Reference: Hanford Waste Vitrification Plant
DOE Contract DE-AC06-86RL10838
Fluor Contract 8457

DESIGN CHANGE NOTICE

DCN -0100 | REV 0 | PAGE 1 OF 18

DCN TITLE: THIS DCN-0100 SUPERSEDES "DCN-0096" & "DCN-0096 REV 1"

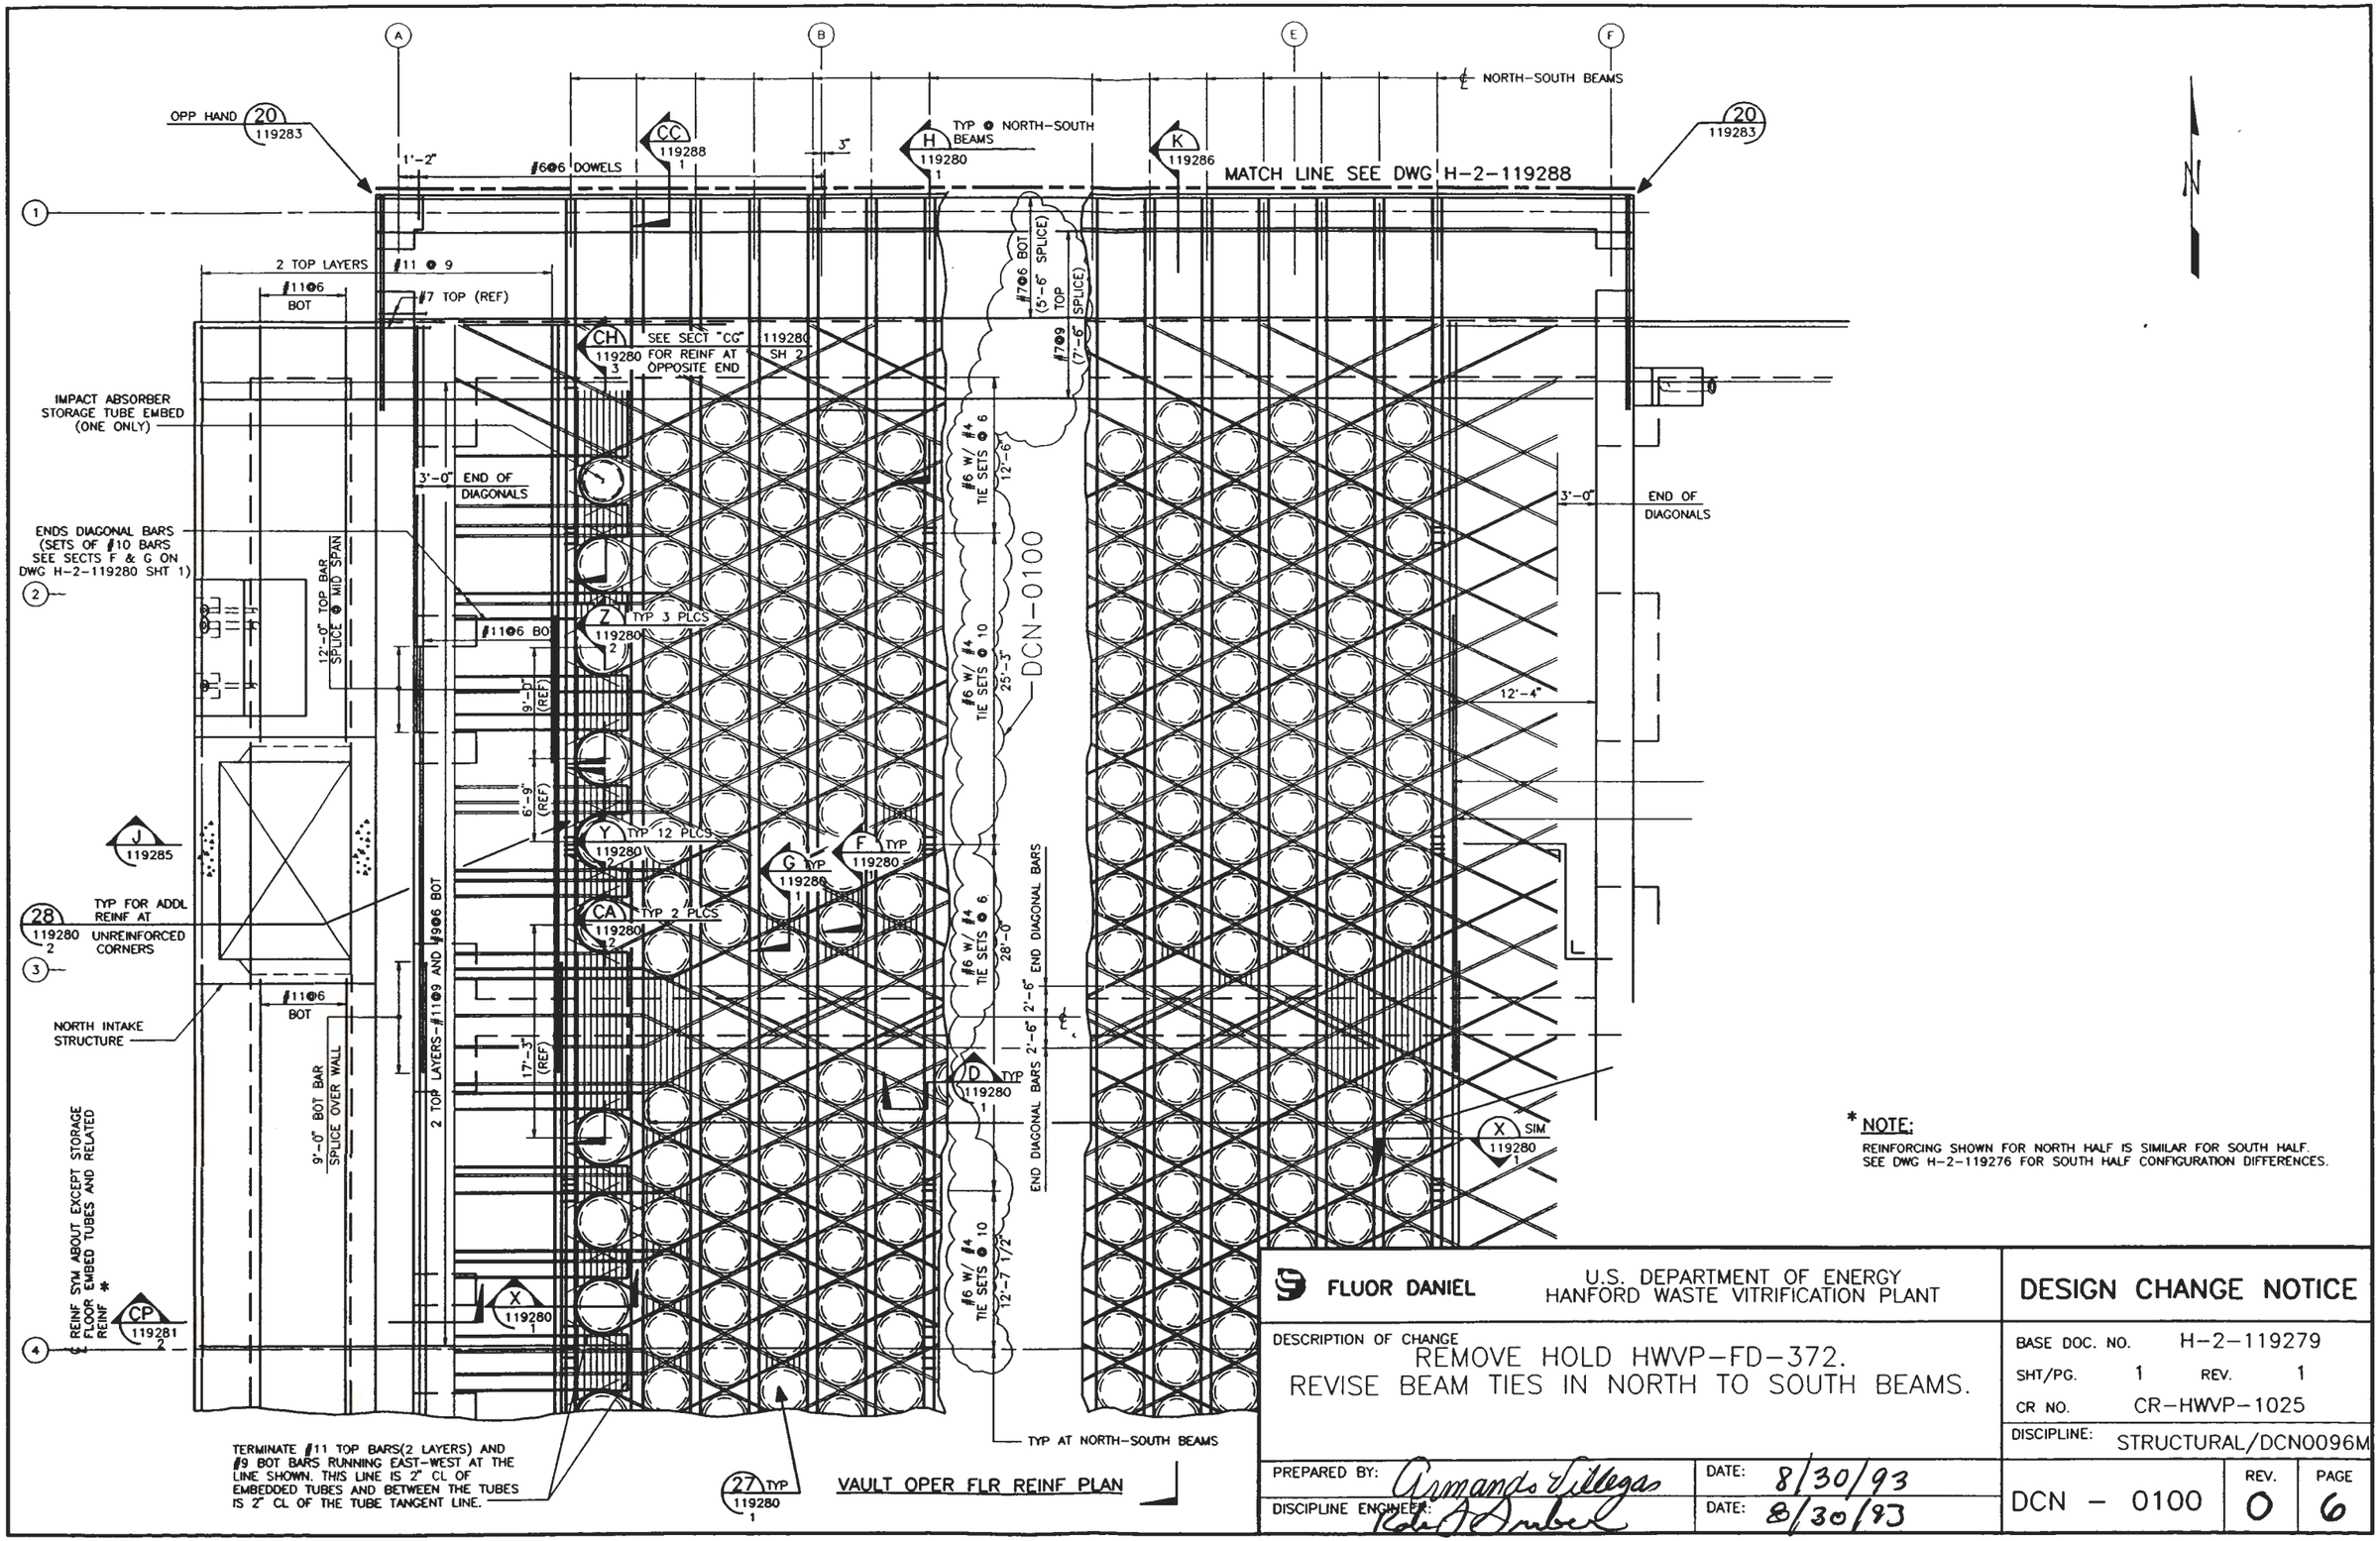
FLUOR DANIEL	U.S. DEPARTMENT OF ENERGY HANFORD WASTE VITRIFICATION PLANT	DESIGN CHANGE NOTICE
DESCRIPTION OF CHANGE REMOVE HOLD HWVP-FD-372. REVISE BEAM TIES IN NORTH TO SOUTH BEAMS.		BASE DOC. NO. H-2-119279 SHT/PG. 1 REV. 1 CR NO. CR-HWVP-1025 DISCIPLINE: STRUCTURAL/DCN0096M
PREPARED BY: Armands Villegas	DATE: 8/30/93	DCN - 0100 REV. 0 PAGE 6
DISCIPLINE ENGINEER: Robert Imbert	DATE: 8/30/93

SECTION D 119279

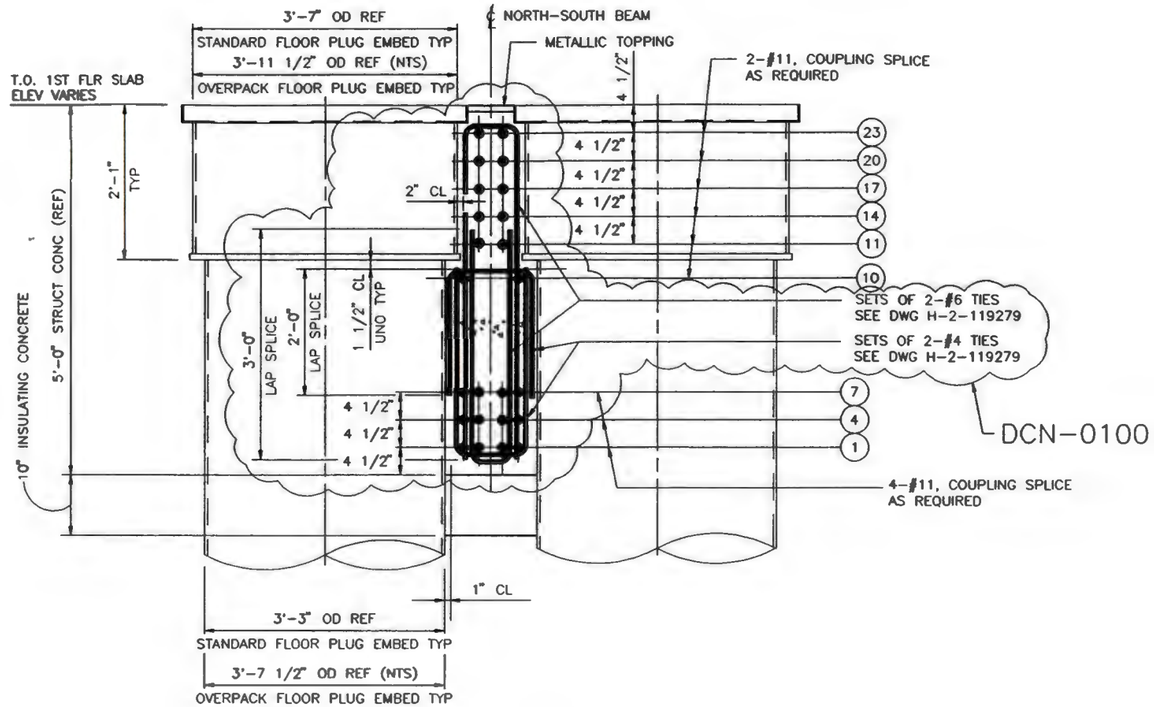
FLUOR DANIEL	U.S. DEPARTMENT OF ENERGY HANFORD WASTE VITRIFICATION PLANT	DESIGN CHANGE NOTICE
DESCRIPTION OF CHANGE: REMOVE HOLD HWVP-FD-372. REVISE REINFORCING TIES.		BASE DOC. NO. H-2-119280; SHT/PG. 1 REV. 1; CR NO. CR-HWVP-1025; DISCIPLINE: STRUCTURAL/DCN0096N
PREPARED BY: Armando Villegas	DATE: 8/30/93	DCN - 0100 REV. 0 PAGE 7
DISCIPLINE ENGINEER: Rob A. Jubb	DATE: 8-30-93

SECTION F 119279

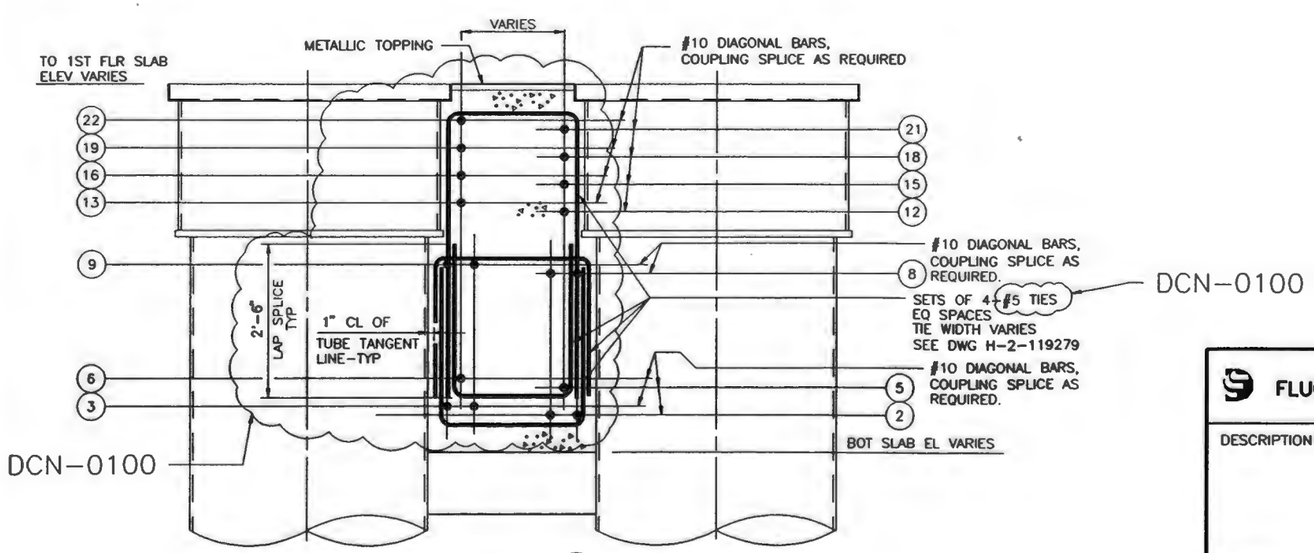
NUMBER	REV	DATE	TITLE
DCN NUMBER - 0100	0	08/30/93	DCN TITLE - THIS DCN -0100 SUPERSEDES "DCN-0096 & 0096R1 "APPROVED FOR CONSTRUCTION" THE ADDITIONAL REINFORCING TIE CHANGES WERE MADE ON THIS DCN-0100: SEE TIES ON SECTION F & 7, SECTION G & DET 27 PAGE 8, SECTION Y & Z PAGE 9, SECRION CA PAGE 10 AND SECTION CH PAGE 11

SECTION G
119279

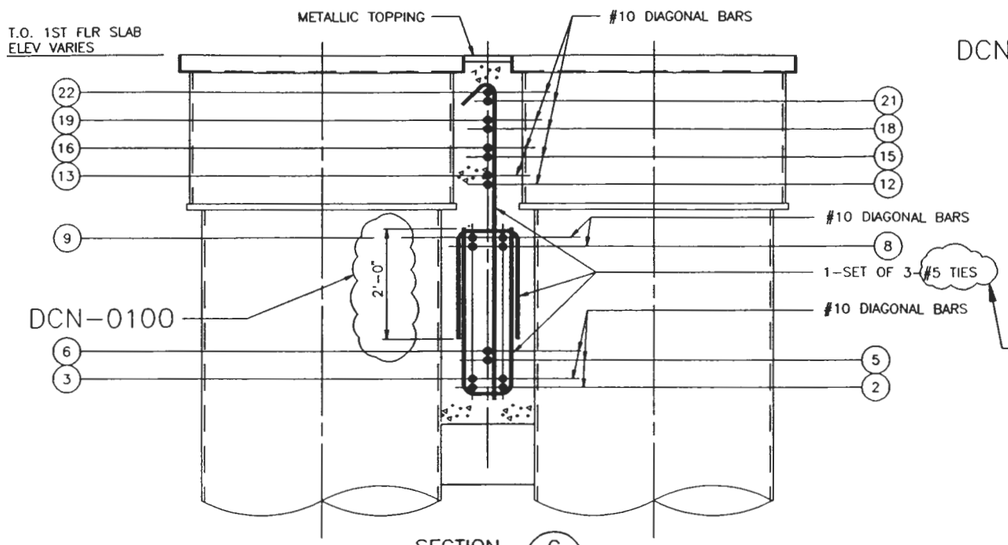
FLUOR DANIEL	U.S. DEPARTMENT OF ENERGY HANFORD WASTE VITRIFICATION PLANT	DESIGN CHANGE NOTICE
DESCRIPTION OF CHANGE REMOVE HOLD HWVP-FD-372. REVISE REINFORCING TIES.		BASE DOC. NO. H-2-119280 SHT/PG. 1 REV. 1 CR NO. CR-HWVP-1025 DISCIPLINE: STRUCTURAL/DCN00960
PREPARED BY: Armando Villegas	DATE: 8/30/93	DCN - 0100 REV. 0 PAGE 8
DISCIPLINE ENGINEER: Rale J. Snuler	DATE: 8-30-93

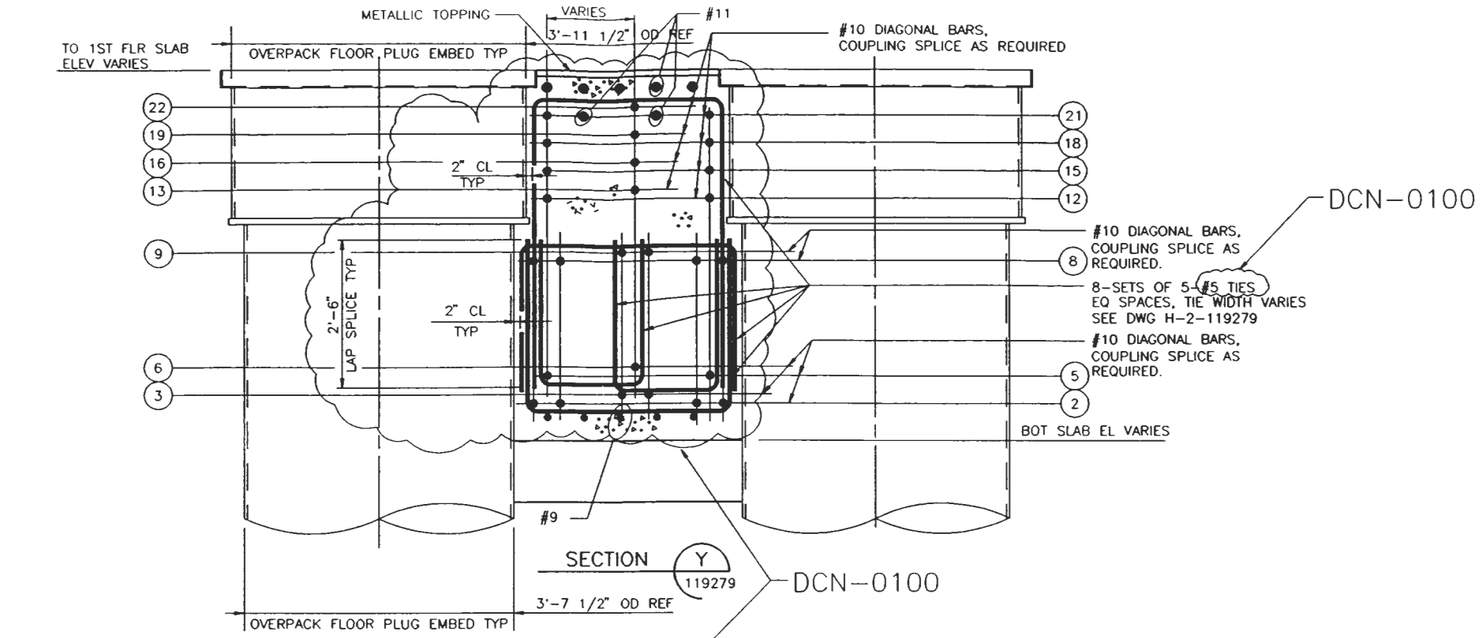
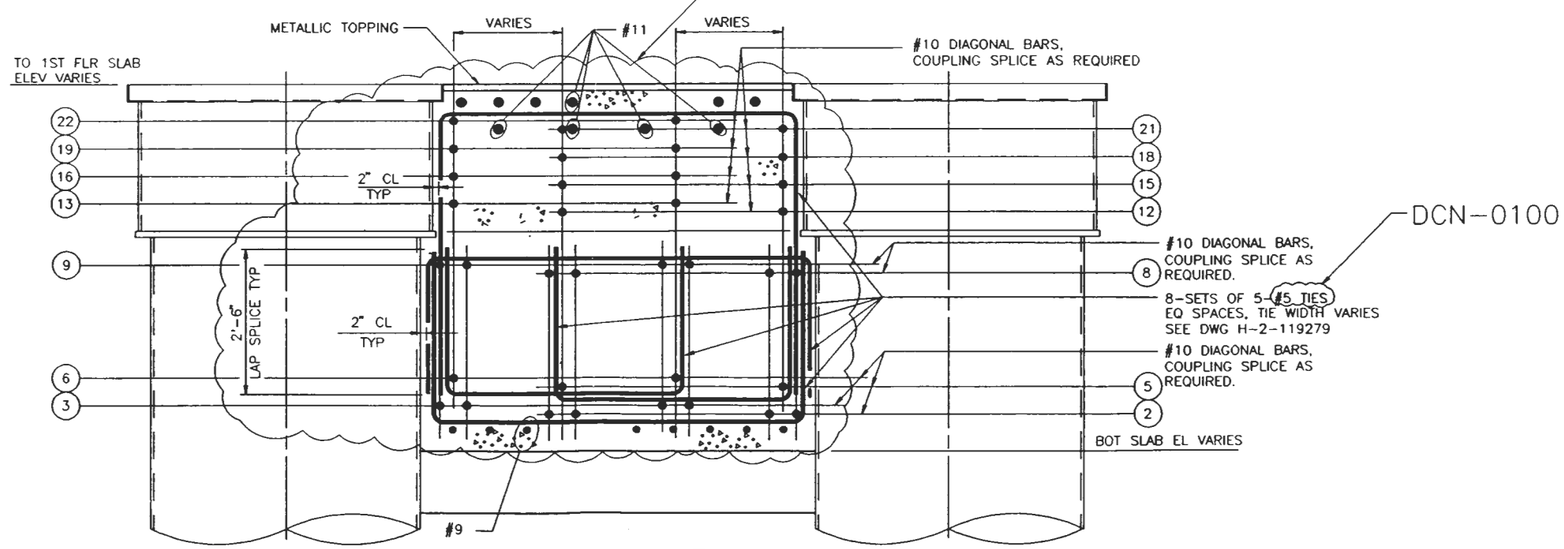
FLUOR DANIEL	U.S. DEPARTMENT OF ENERGY HANFORD WASTE VITRIFICATION PLANT	DESIGN CHANGE NOTICE
DESCRIPTION OF CHANGE REMOVE HOLD HWVP-FD-372. REVISE REINFORCING TIES.		BASE DOC. NO. H-2-119280 SHT/PG. 2 REV. 1 CR NO. CR-HWVP-1025 DISCIPLINE: STRUCTURAL/DCN0096P
PREPARED BY: Armando Villegas	DATE: 8/30/93	DCN - 0100 REV. 0 PAGE 9
DISCIPLINE ENGINEER: Robert J. Gruber	DATE: 8-30-93

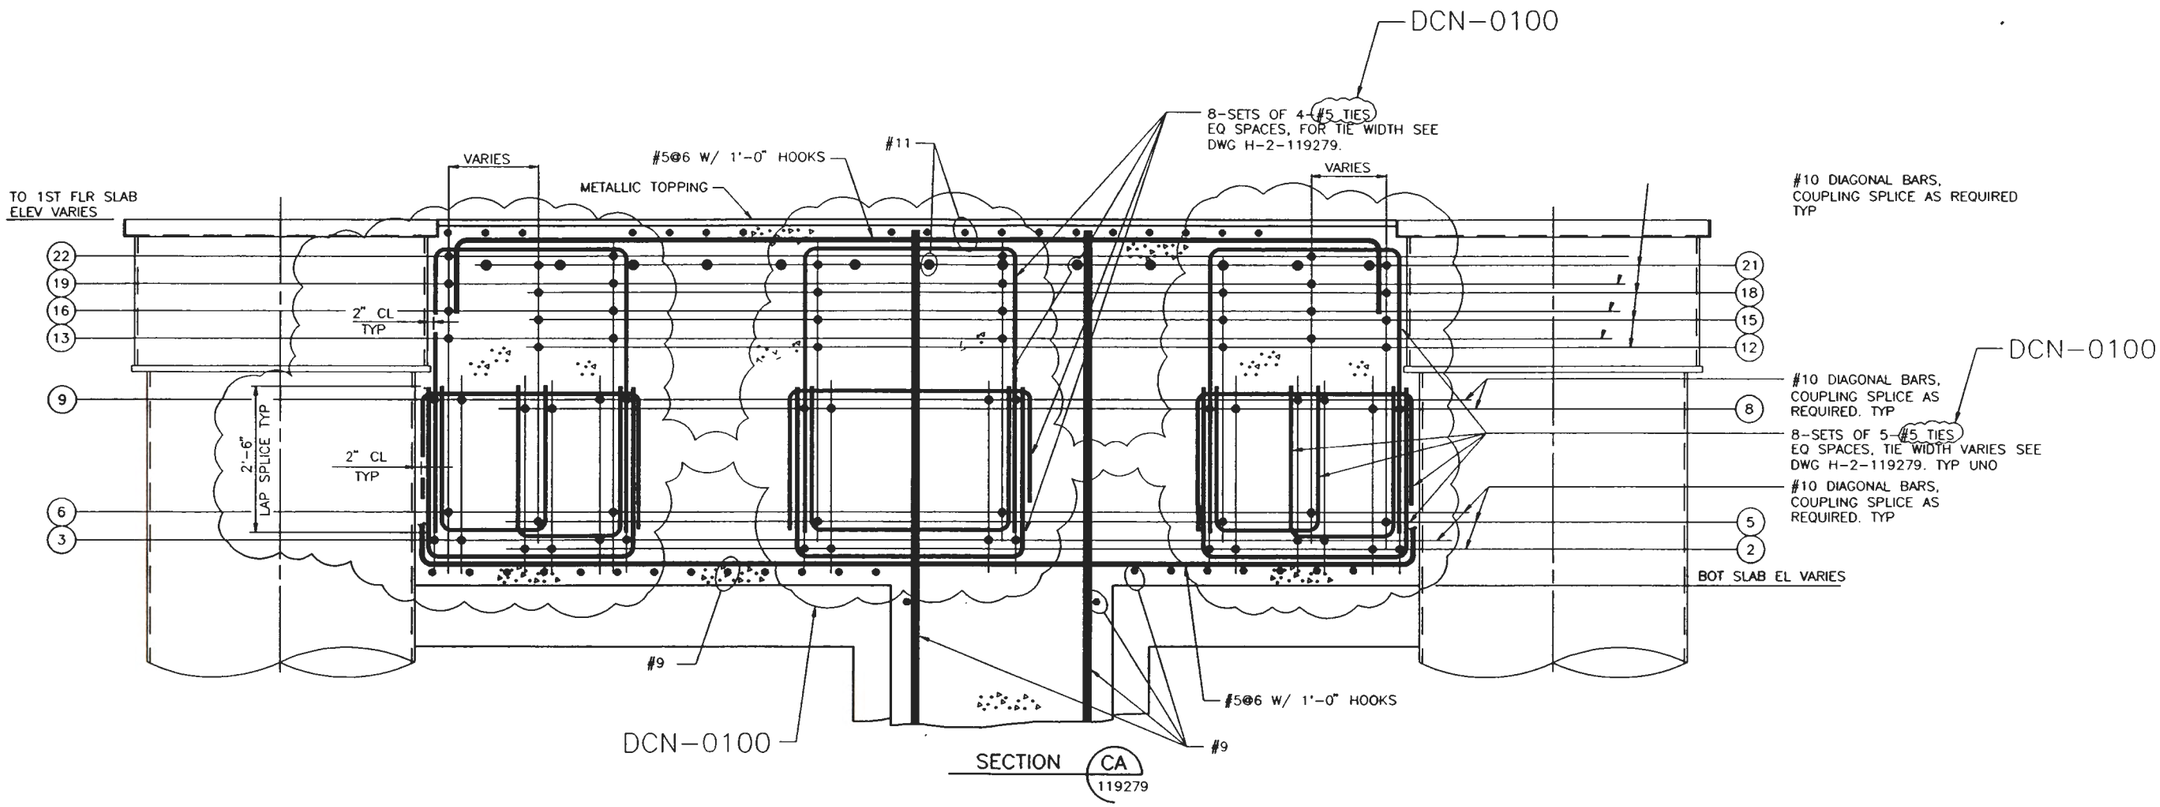
FLUOR DANIEL	U.S. DEPARTMENT OF ENERGY HANFORD WASTE VITRIFICATION PLANT	DESIGN CHANGE NOTICE
DESCRIPTION OF CHANGE REMOVE HOLD HWVP-FD-372. REVISE REINFORCING TIES.		BASE DOC. NO. H-2-119280 SHT/PG. 2 REV. 1 CR NO. CR-HWVP-1025 DISCIPLINE: STRUCTURAL/DCN0096Q
PREPARED BY: Armando Villegas	DATE: 8/30/93	DCN - 0100 REV. 0 PAGE 10
DISCIPLINE ENGINEER: Robert A. Gruber	DATE: 8-30-93
